Initial Appraisal Sacramento River Flood Control Project (Glenn-Colusa), California

INITIAL APPRAISAL

SACRAMENTO RIVER FLOOD CONTROL PROJECT (GLENN-COLUSA), CA

SACRAMENTO DISTRICT TECHNICAL REVIEW AND ANALYSIS

FIGURE 3
SITE PLAN
PROPOSED GRADIENT WEIRS FOR
WATER SURFACE RESTORATION
GLENN-COLUSA IRRIGATION DISTRICT
CHM/HILL

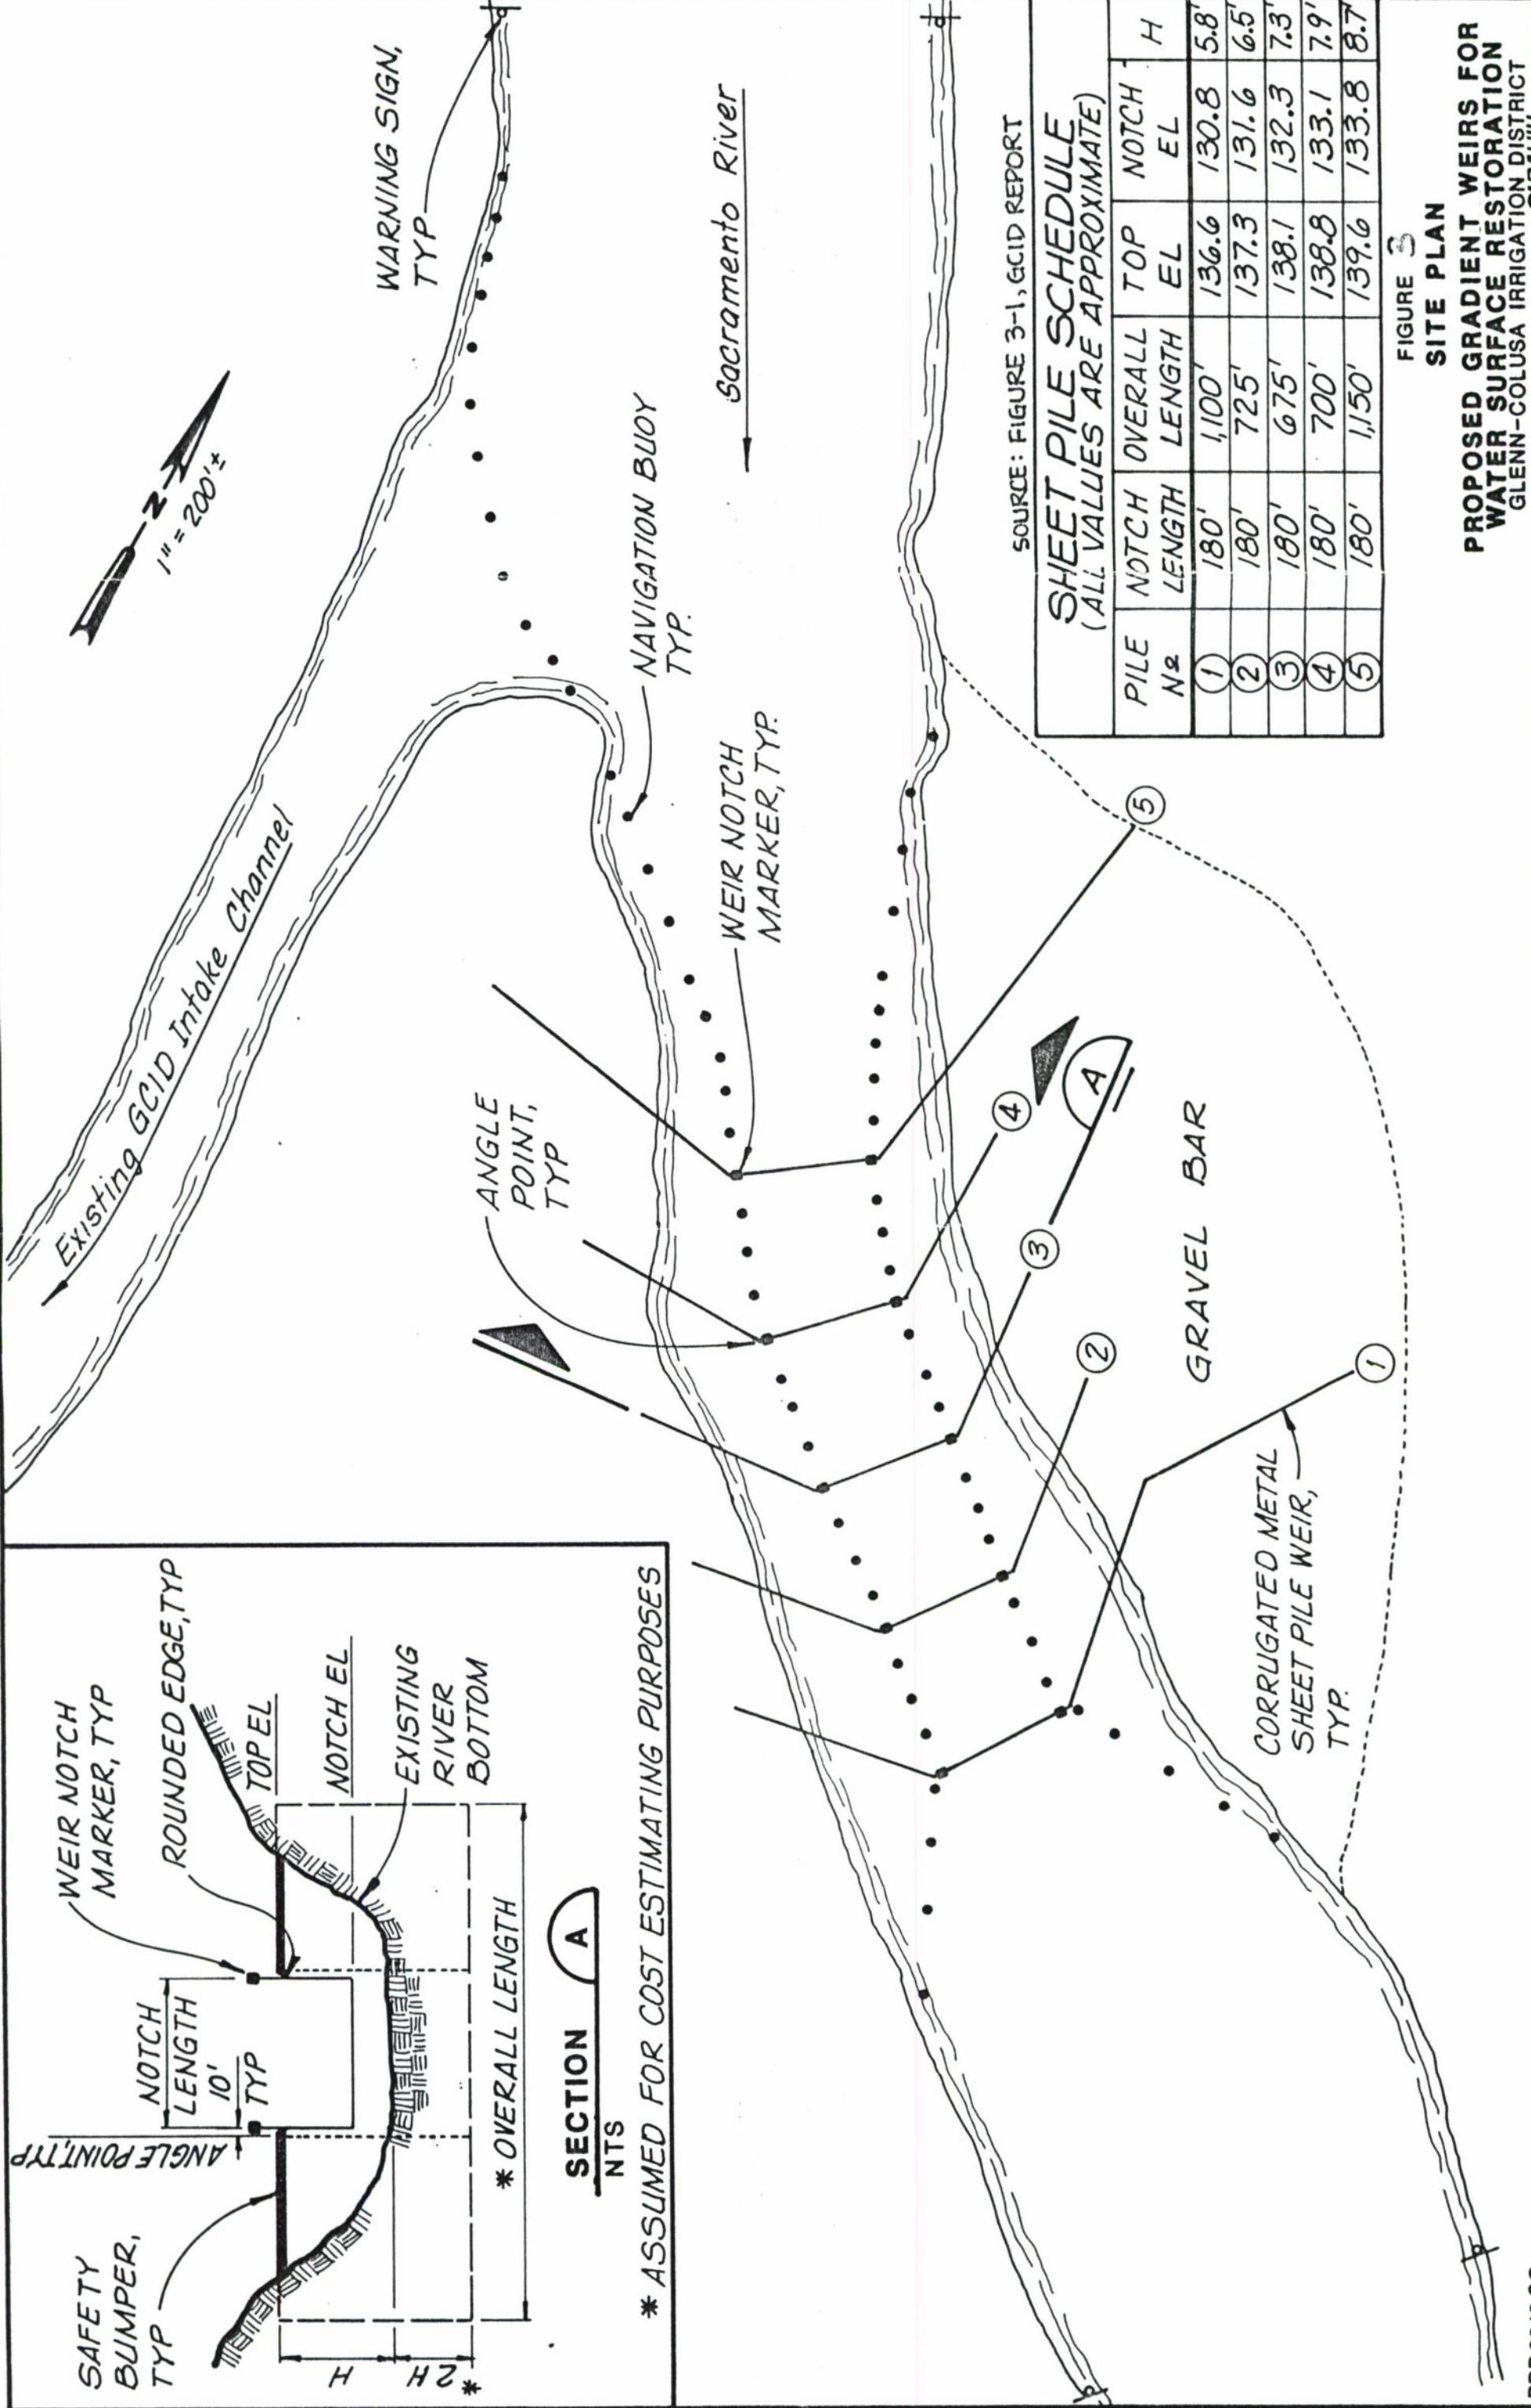
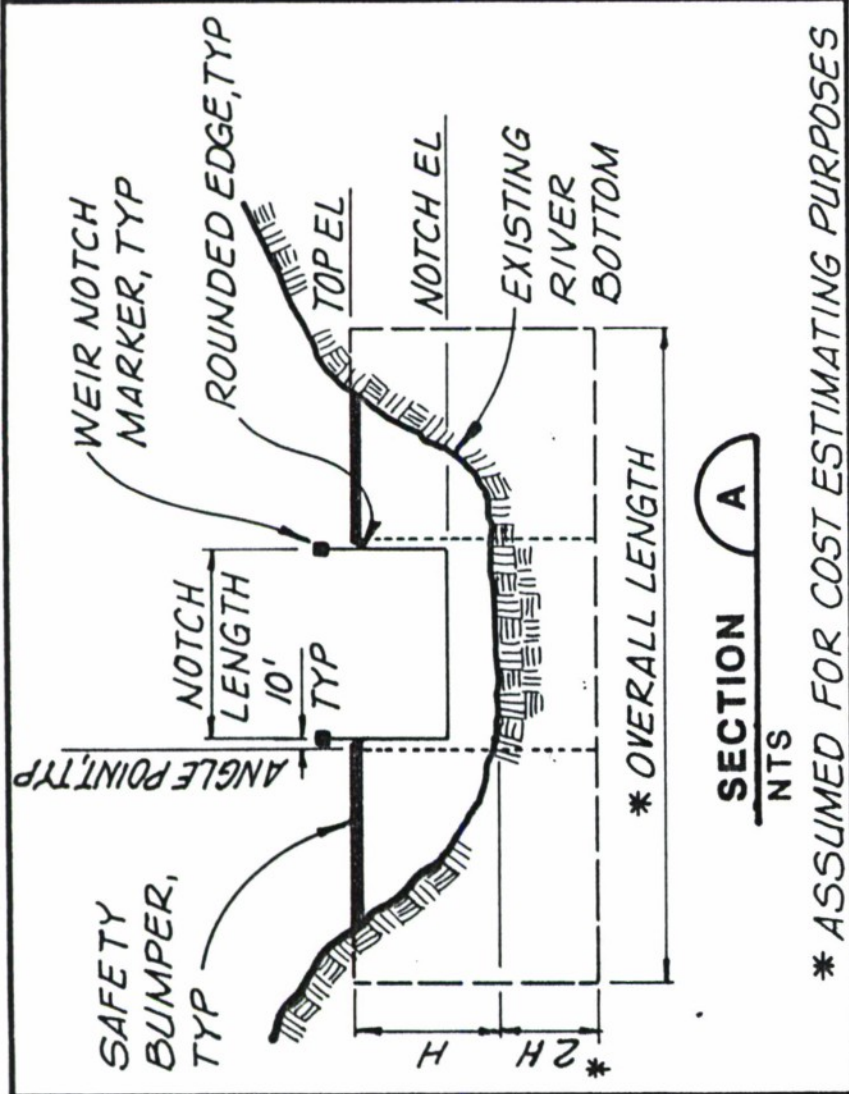
Although the GCID report is a good report that examines the most reasonable means to control the river gradient in this river reach, further study is needed for the following: (1) bank protection cost estimates, (2) additional subsurface information to determine whether the sheet piles are of correct length and width, and (3) protection measures for the riverbed between sheet-pile weirs.

The cost estimates provided in the GCID report for the gradient restoration structure and annual operation and maintenance costs are limited in detail, and require further analysis. The basic design of the structure, including the length and width of the sheet piles need to be confirmed. More extensive bank protection work may be required to prevent the river from eroding around the structure. Any improvements to the design of the structure and project mitigation measures may increase the cost of the project. Although more refined studies are required, the cost estimates in the GCID report appear reasonable for this stage of project development. After adding overhead, contingencies, engineering and design, supervision and administration, and other costs, the cost of the structure is estimated at \$5,530,000. The total project costs for all three alternatives are shown in Table 3. A slight increase in annual costs over GCID estimates occurs when an interest rate of 8-7/8 percent (rather than 8-5/8 percent) is used.
